QUESTION 1:

PROJECT NO.	20113
DATE	08/13
BY	
CHECKED BY	
DESIGNED BY	
IN CHARGE	
APPROVED BY	
DATE	
PROJECT NO.	20113
DATE	08/13
BY	
CHECKED BY	
DESIGNED BY	
IN CHARGE	
APPROVED BY	
DATE

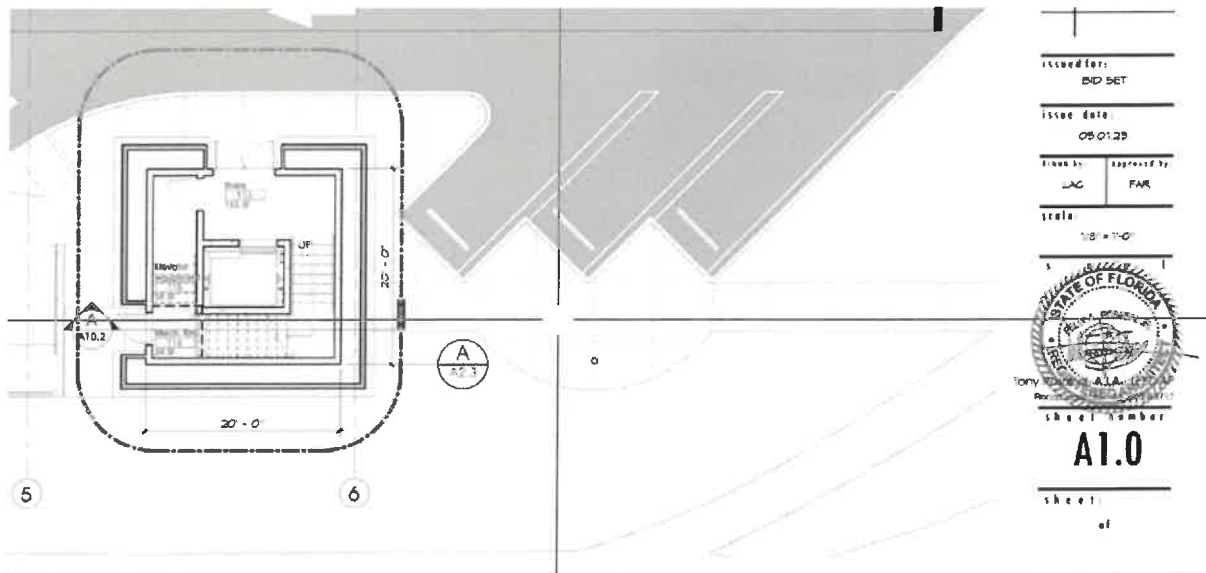
QUESTION 3: Finish schedule for tower stairs calls out for Luxury tile. Please specify if each landing ought to have Luxury tile at the landing but not the steps?

Luxury tile at landings and steps (tread, riser and landing tiles).

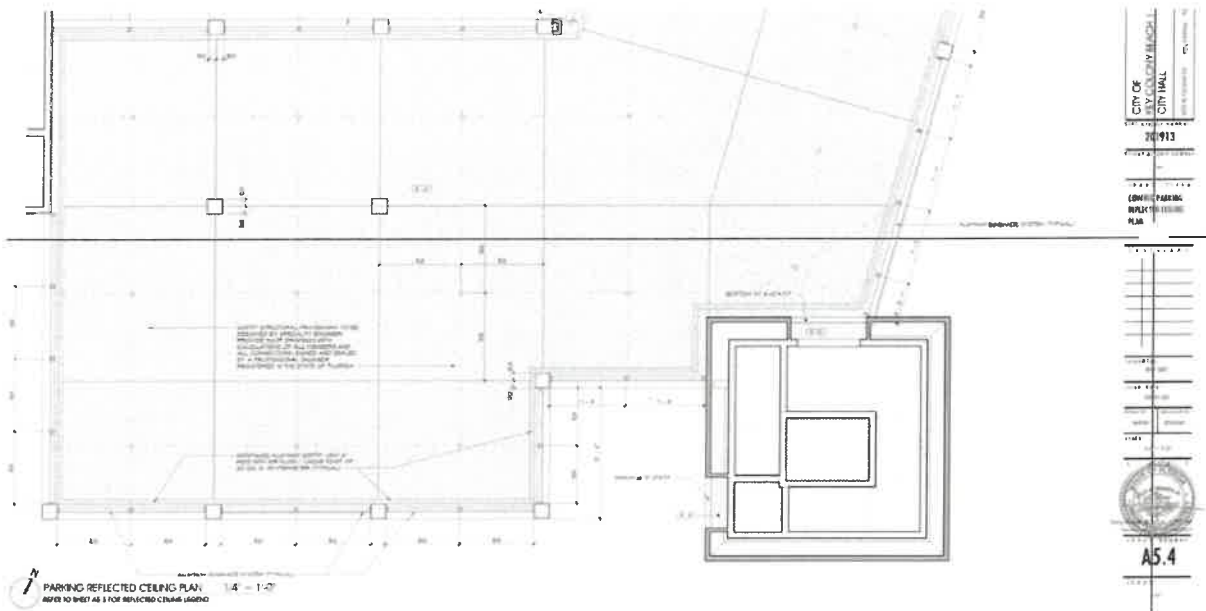
Sheet A5.4 shows structural soffit. Can we show this as an allowance since we cant possible estimate this without a bid award and contract which allow GC to actually hire a structural engineer to design the soffit. We will consider for now 18 gage framing at 16 o.c. and 2 1/2" hihats at 24 o.c. in the opposite direction. This will be the basis of our allowance if accepted with this question

This is acceptable.

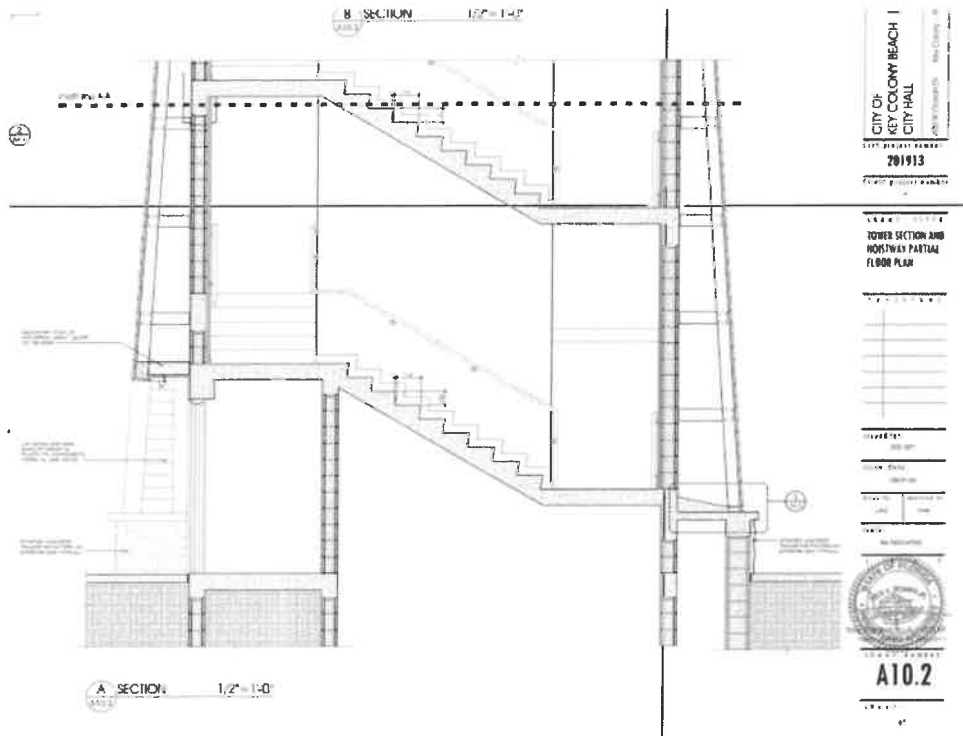
Sheet A 10.2 Stair border is shown but not identify. Please clarify
Vinyl base is called out in finish schedule on sheet A6.0

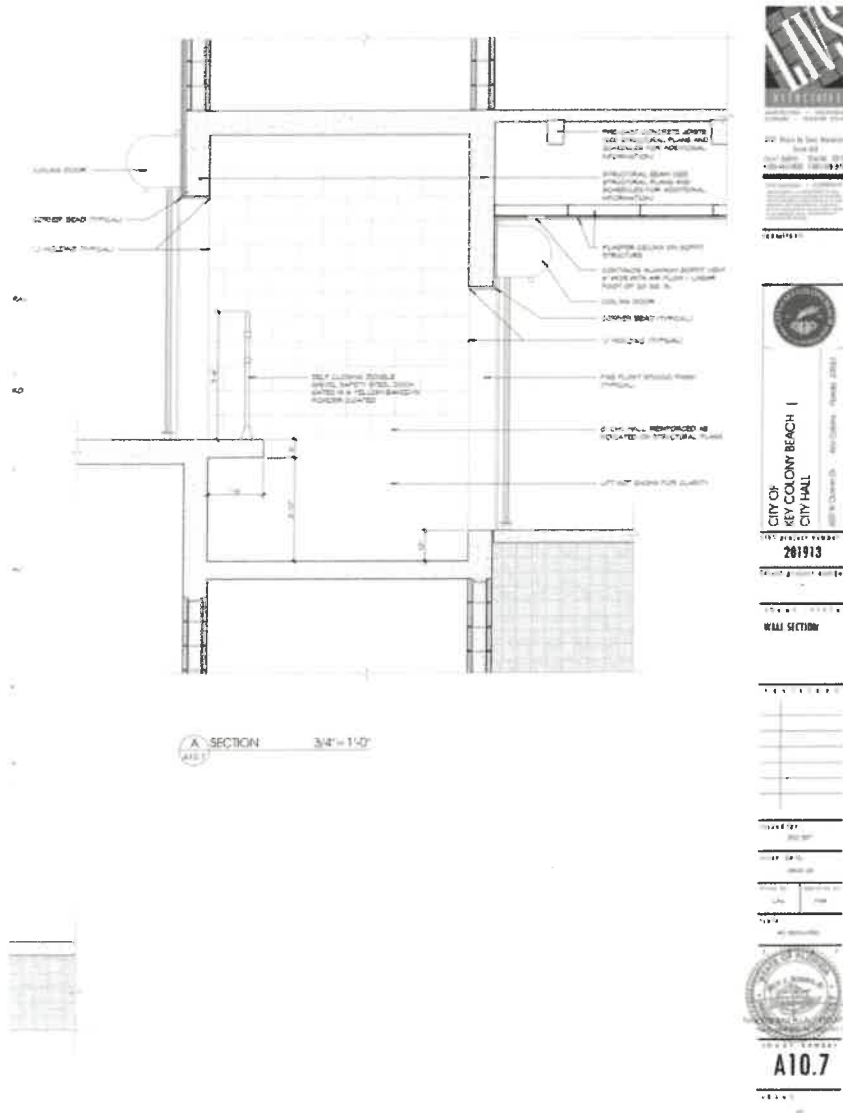
Sheet A10.2. Section through elevator shaft is not shown.

1. Please provide section showing hoist beam detail and connection to beam
2. Please provide depth of elevator pit
3. Elevator manufacturer is not specified not capacity

1. Refer to section 2/S3.0 and detail 6/S2.1
2. Refer to section 2/S3.0
3. Refer to specification section 14240 for manufacturer.
